SECTION C THEATRE DOORS @ GALLERY 2ND LEVEL 1/2" = 1'-0"

ACC ADDISON ACT

ELEVATION OF ROLLING CATWALK 1/2" = 1'-0"

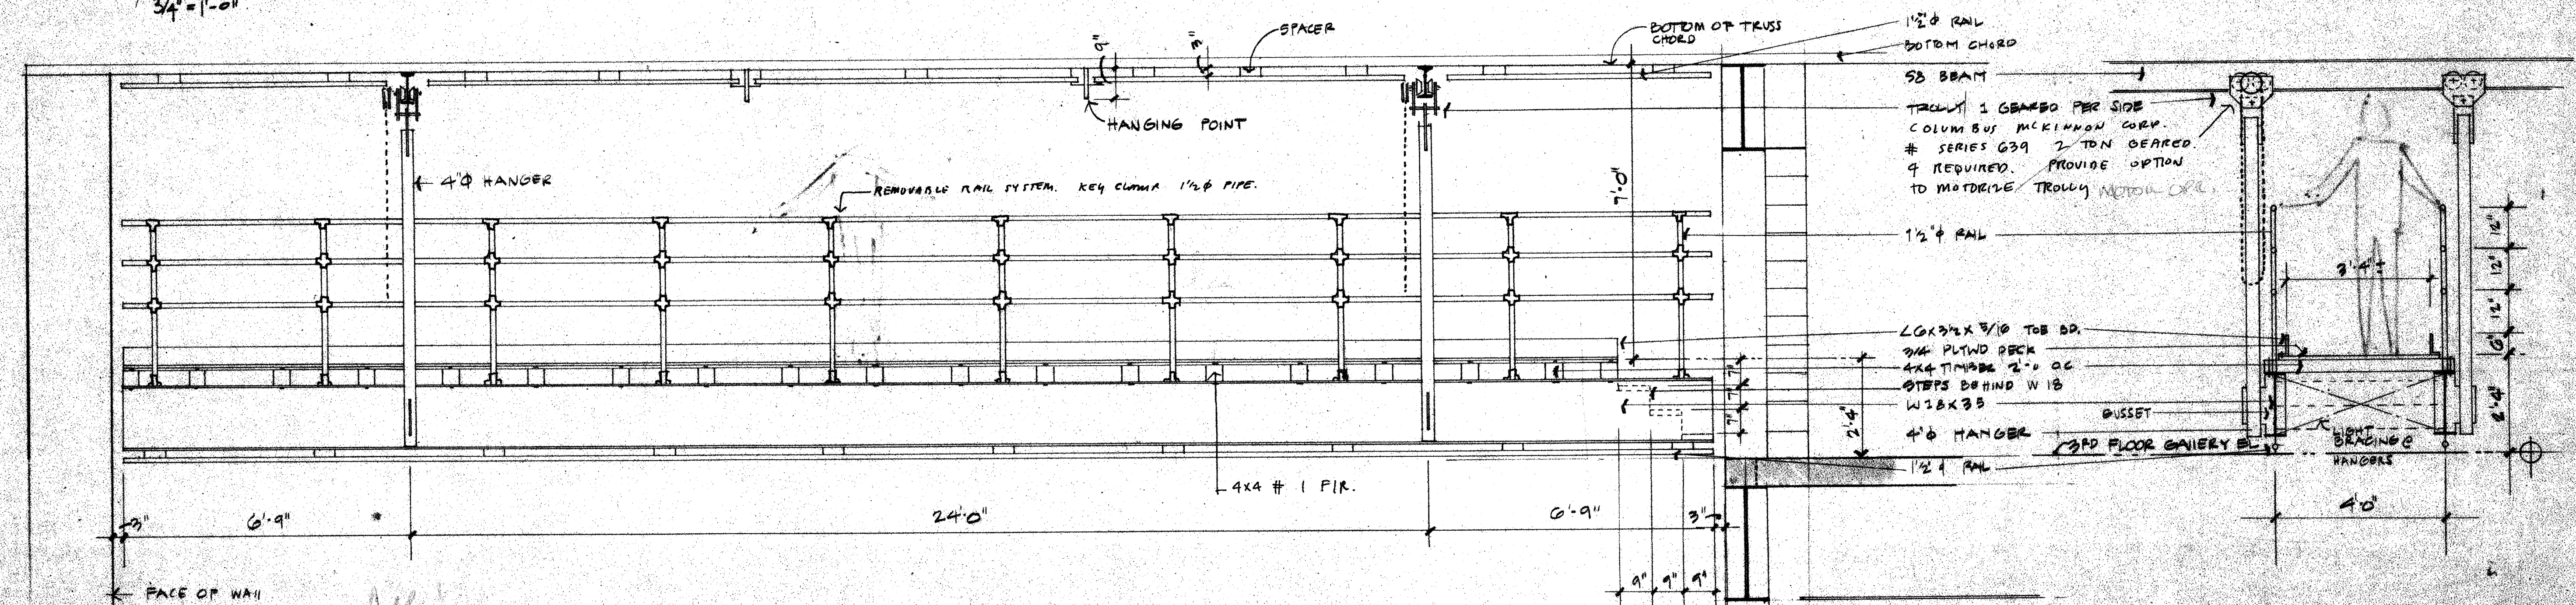
N. I. C. O M I T
